County of Fairfax, Virginia
Planning Commission Meeting
July 9, 2025
Planning Commission Action

2232-2024-SU-00008 – TOWERVIEW SUBSTATION
(Sully District)

Application Number:	**2232-2024-SU-00008**
Applicant:	**Dominion Energy**
Proposed Use:	Towerview Electrical Substation
Supervisor District:	Sully
Subject Property Tax Map ID:	24-2-((1))-11C2
Subject Property Address:	13921 Park Center Rd, Herndon, VA
Area of Subject Property:	3.79 acres
Application Accepted:	September 5, 2024. The Board of Supervisors extended the application deadline on October 22, 2024 to August 4, 2025 date, in order to allow the applicant and staff sufficient time to complete the 2232 review.
Recommendation:	In accordance with Va. Code Sec. 15.2-2232, as amended, staff recommends that the Planning Commission find that the proposal by Virginia Electric and Power Company, d/b/a Dominion Energy Virginia (Dominion) to construct a new substation facility at parcel number 24-2-((1))-11C2 in Herdon, VA **is substantially in accord** with provisions of the adopted Comprehensive Plan.

Towerview Substation – Public Facility Review 2232 Referral Comments

2232 EXHIBIT - LANDSCAPE PLANT SCHEDULE AND FENCE/WALL DETAIL

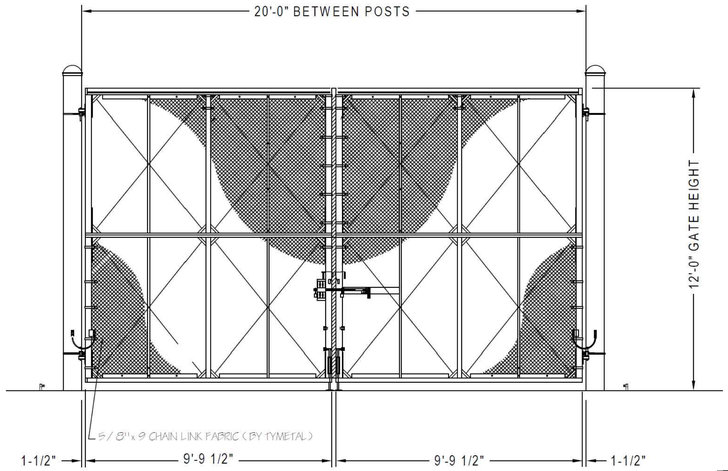
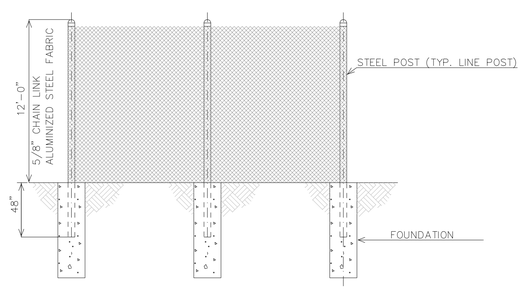
5 DPD-PD	Please ensure development meets the lighting requirements as stipulated in the Zoning Ordinance.	**Since this is an unmanned facility, proposed lighting is minimal except for security and safety purposes at the GIS enclosure doors only and will meet Zoning Ordinance requirements. Light fixtures will be used that minimize glare onto adjacent properties with the use of full cut-off LED lighting.**	
Forest Conservation Branch (FCON) – Site Development & Inspections Division (SDID) Memo dated 11/15/24 (Updated Memo)			
1 FCON/ SDID	Comment: The examination of the required transitional screening and barrier requirements has not been provided in the submission. Recommendation: The applicant should provide the required transitional screening and barrier requirements for the proposed substation.	**The landscape plan that is part of the Dulles Gateway site plan (#SP-2023-0089) is shown on sheets 5 and 6 of the 2232 plan and meets or exceeds Zoning Ordinance requirements. In response to County comments, we have worked with the developer to enhance the screening for the substation.** **To the east, south, and west, the area of the substation is bordered by industrial, data center, highway, and airport uses. Table 5108.2 indicates that no transitional screening or barrier is required to the east and south because of like industrial zoning. To the west, it is residentially zoned land, but developed with highway and airport uses. It is noted that the residual R-1 zoning to the west is left over from the original airport development, which is exempt from local zoning regulations. Despite no transitional screening requirements for the use, the western and eastern sides of the substation have been planted to the greatest extent possible for maximum visual mitigation. The southern side of the site is facing the data center buildings and impacted by transition lines entering the site and the data center access roads. In response to comments, four trees have been added at the southeast corner.** **To the north, the site is adjacent to residential development. As shown on the Dulles Gateway site plan (#SP-2023-0089) and included on Sheets 5 and 6 of the 2232 plan, an extensive transitional screening buffer is provided on the north side of the site ranging in width from 115' to 195' and is fully planted with a mix of evergreen and deciduous trees and shrubs with mature heights that will range from 50'- 100' at maturity. In addition, three (3) tree save areas are preserved within the landscape buffer, along the northern property line closest to the residential community. The proposed northern landscape buffer greatly exceeds the Type 2 transitional screening requirements of the Zoning Ordinance.** **Further, the site meets or exceeds barrier requirements. On the north side, the data center developer is providing a 6' board-on-board fence on the northernmost boundary of the property, adjacent to the residential townhomes, which meets Barrier E requirements. Dominion is also providing an additional barrier on the north side of the substation pad site which consists of a solid, 12' decorative pre-cast concrete wall meeting Barrier D requirements. With two barriers provided, the north side of the site exceeds zoning ordinance requirements.** **Although there are no barrier requirements on the east, south, and western sides, Dominion is providing a 12' security fence along the southern and western boundaries which, as well as a solid 12' precast concrete decorative wall along the eastern side of the substation.**

Landscape Plan

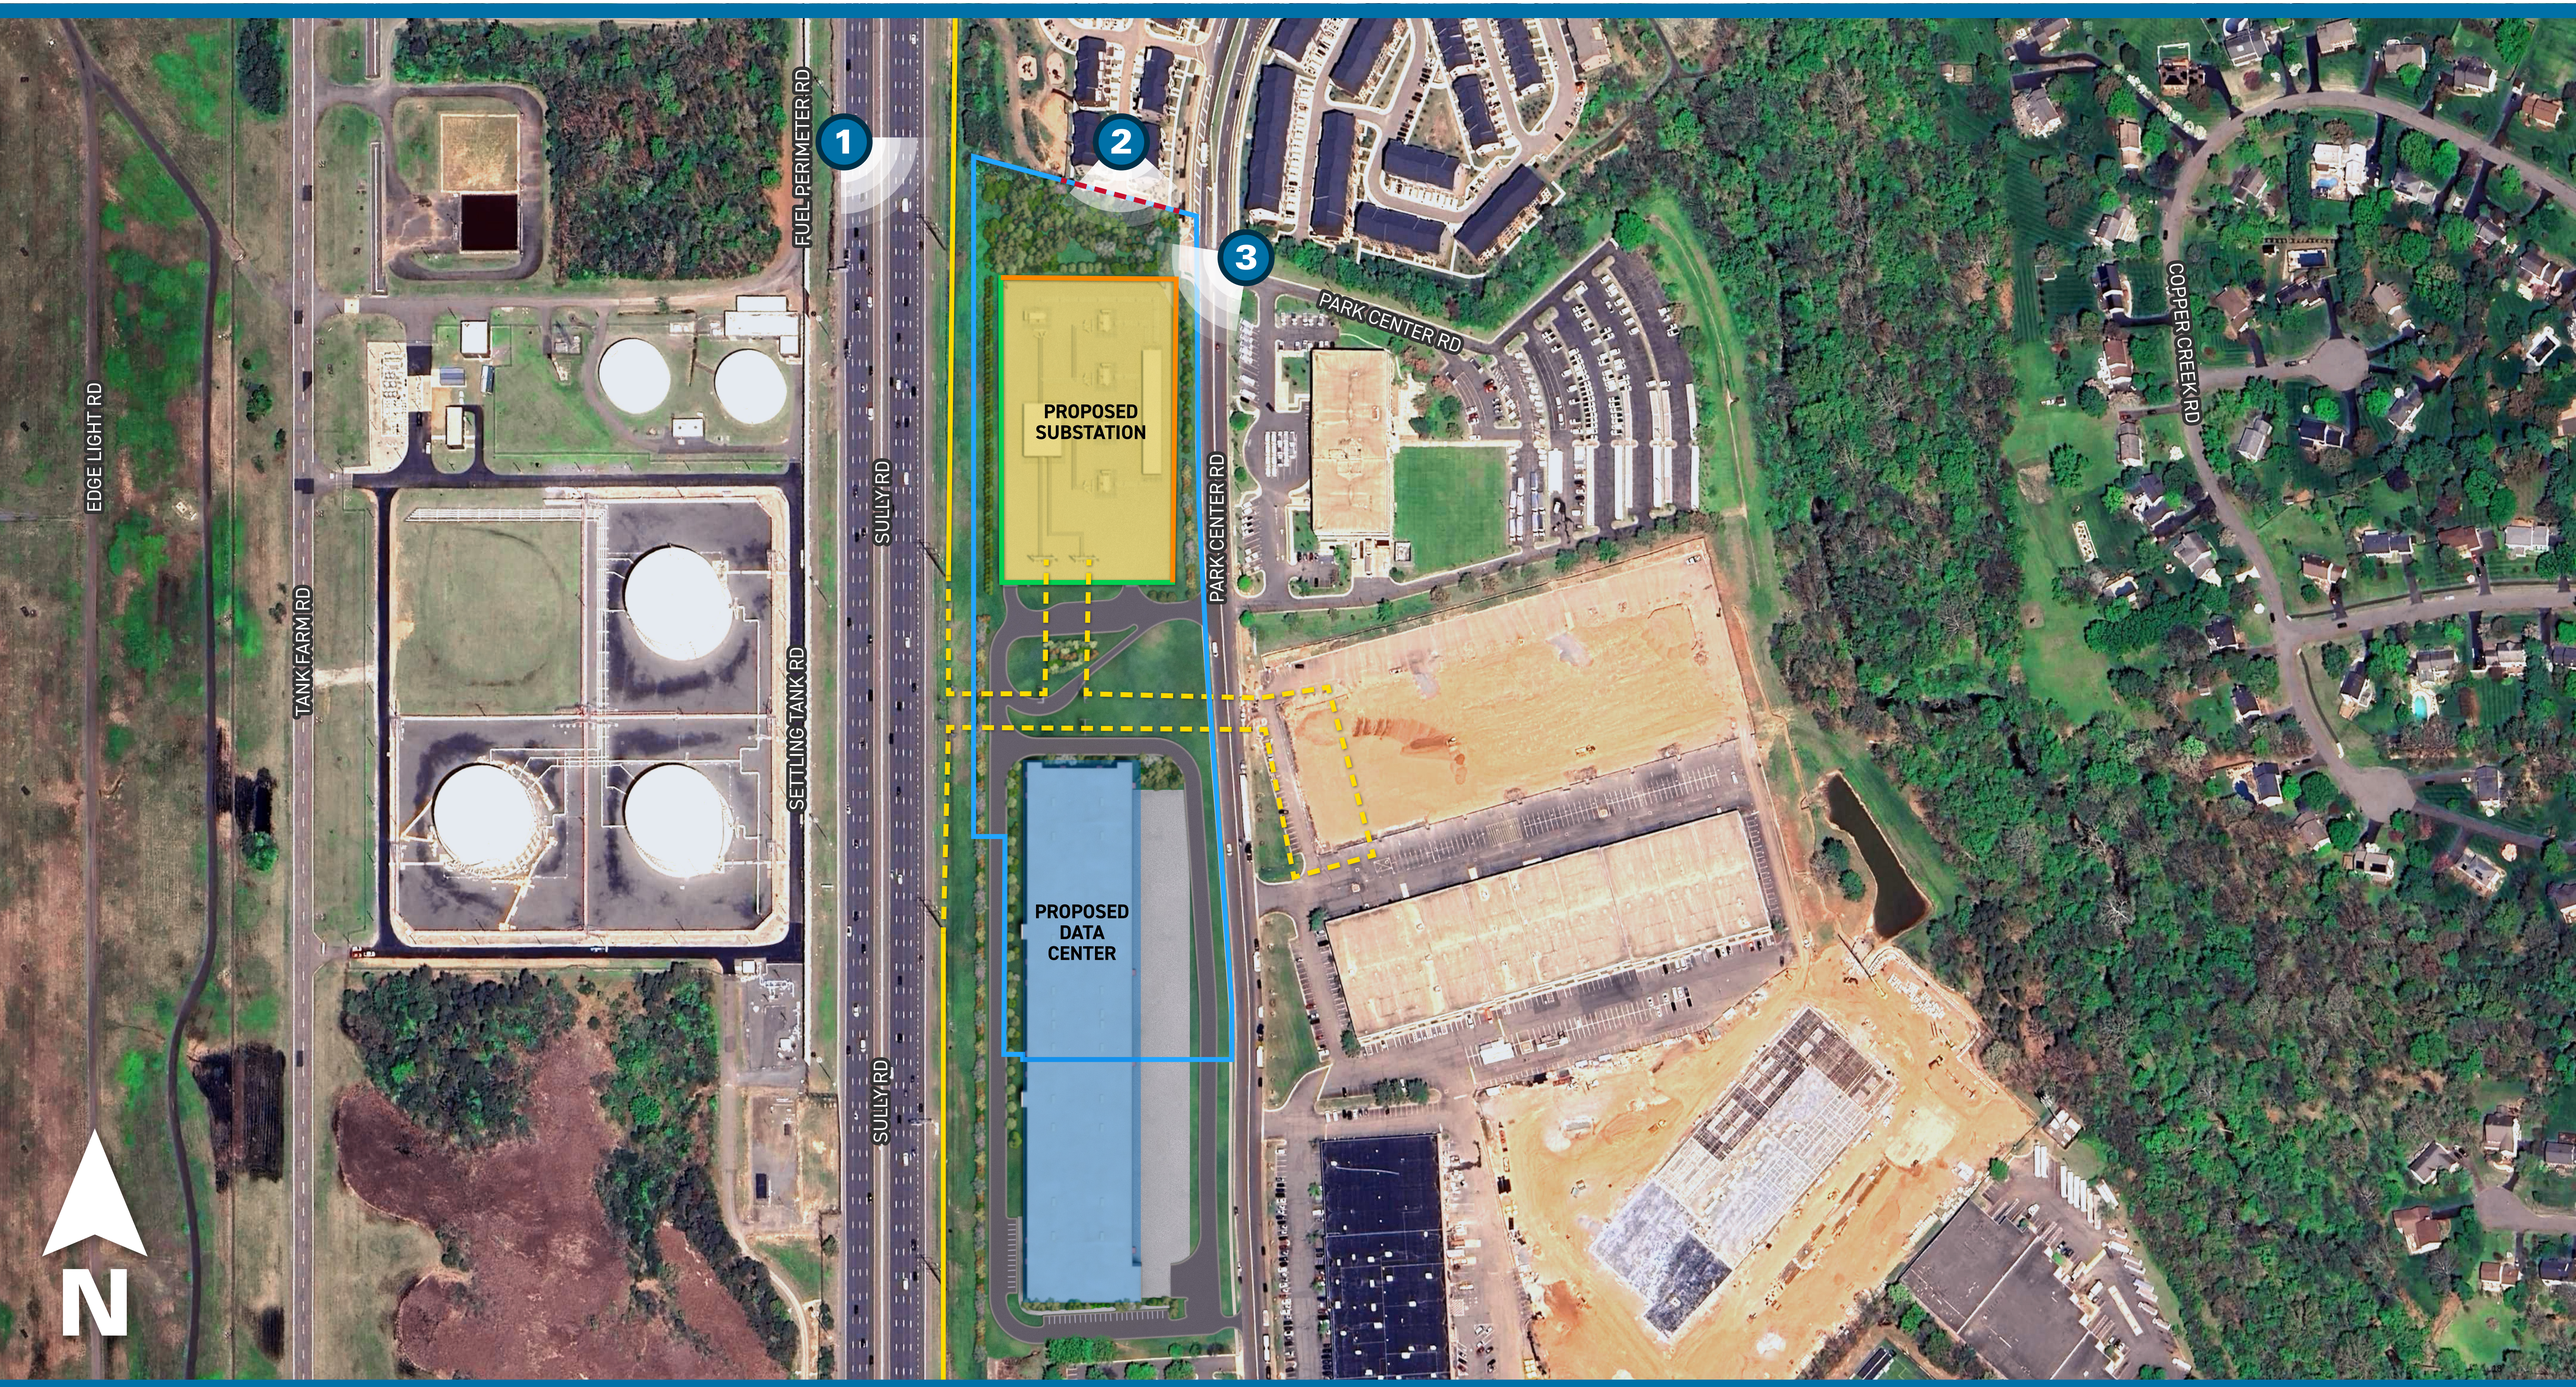
2 PFPD	Please provide landscape plan, aerials of the proposed site and the adjacent uses from a bird's eye view.	**The landscape plan is shown on sheets 5 and 6 of the 2232 plan. An aerial of the site and adjacent uses have been included in the attached exhibits.**	
3 PFPD	Please provide more graphics/illustrations.	**Graphics and illustrations are included in the attached exhibits.**	
4 PFPD	Is this the best place for the proposed development, can it be located somewhere closer to the data center? Per Objective 1, Policy a of the PFEPP.	**The substation pad site cannot be moved closer to the data center buildings due to internal roadways and transmission lines that enter the site.**	
5 PFPD	Please expand on why the proposed development cannot be screened more. How will you ensure that it looks and blends in with the character of the road and residential uses to the northeast of the site. Per Objective 44, Policy b of the PFEPP.	**The subject property is zoned I-5, Industrial, and the property immediately across the road is also zoned I-5. Historically, the character of the area has been developed with industrial warehouse uses since the 80's. That said, with the new residential community to the north of this site, the substation has been intentionally designed to look and blend with the mixed character of the area that includes the industrial, data center, and residential uses. For example, Dominion is proposing a 12-foot decorative wall on the eastern and northern sides of the site to provide a more aesthetically pleasing look for the screening barrier. Also, as noted in the statement of justification, because this is a smaller substation site, GIS enclosures are provided for much of the substation equipment which also serves to shield views of equipment.** **Screening for the overall property is provided by the data center site plan and is in accordance with the zoning regulations. It is important to note the landscape plan provides for a substantial buffer on the northern side of the property, adjacent to the residential community, which greatly exceeds zoning ordinance requirements. The northern buffer ranges in width from 115' to 195' wide and is planted with a**

8 PFPD	Can you please show exhibits of the vegetated buffer that is proposed to separate the development and the residential subdivision to the northeast.	**The landscape plan is shown on sheets 5 and 6 of the 2232 plan. Further, exhibits are included with this submission that show the extensive buffer that separates the substation and the residential subdivision to the north.**	
9 PFPD	People will be concerned with the magnetic fields from the proposed development. What is being done to minimize unnecessary human exposure. Per Objective 43, Policy h and Objective 44, Policy i of the PFEPP.	**<u>Objective 43, Policy h</u> - Regulate new development where permissible to minimize unnecessary human exposure to unhealthful impacts of low-level electromagnetic fields (EMF) from electrical transmission lines.** **<u>Objective 44, Policy i</u> - Assure that radiation levels, individually and cumulatively, will be maintained at acceptable levels.** **Response: EMF, at various frequencies, is naturally present everywhere in the environment. It is also created whenever an electrical current is used. It is not only found near transmission and distribution lines, but also in homes, workplaces, schools, etc. Generally, EMF is levels are associated with the currents in transmission and distribution lines, and EMF levels dissipate quickly the further the distance from the source. It is not anticipated the substation equipment will exceed acceptable emf levels beyond the fence line of the substation. More information may be found on Dominion's website. It includes additional links and brochures that further explain EMF and provides measurements and descriptions of how EMF levels are found in human environments and EMF levels. A link is below:** **https://www.dominionenergy.com/projects-and-facilities/electric-projects/emf** .
